20-COA-0226
639 W. Main St.

Old Louisville Architectural Review Committee
Public Hearing

Bradley Fister, Historic Preservation Specialist
December 2, 2020

151628 B

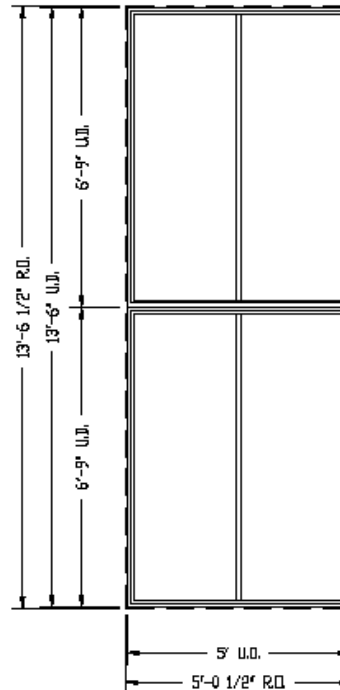
The proposed replacement windows do not meet **W2**, which states that replacement windows match the historic sash dimension, muntin configuration, reveal depths, glass-to-frame ratios, glazing patterns, frame dimensions, and trim profiles. The proposed replacement windows are not a true double-hung wood window and will not replicate the dimensions of a historic window on either the front or rear facade.

Furthermore, the rear historic windows have a 6/6 muntin configuration, which is not proposed to be replicated. **W5** states that contemporary picture windows will not be installed on primary facades. The proposed windows are two picture windows that will be mulled together. The proposed windows do not meet **SF2** and **W6** since they are of a synthetic vinyl material, which these guidelines do not allow on front facades.

However, synthetic materials are allowed on the rear façade. Furthermore, **W7** is not met because the proposed windows would not function as they original windows would have as double-hung. **SF6** and **SF7** are not met because the windows do not replicate the scale or detail of the original windows.

SF26 states do not use storefront design elements that are historically inappropriate, such as small-pane windows or colonial doors on late-nineteenth and twentieth-century buildings, making the proposed mulled window design not historically appropriate for this site.

- 1. The front facade replacement windows shall be 1/1 double-hung windows that fit the historic window openings and contain no muntins.**
- 2. The front façade replacement windows shall be wood or wood clad windows.**
- 3. The rear elevation replacement windows shall fit the historic window openings and contain a 6/6 muntin pattern.**
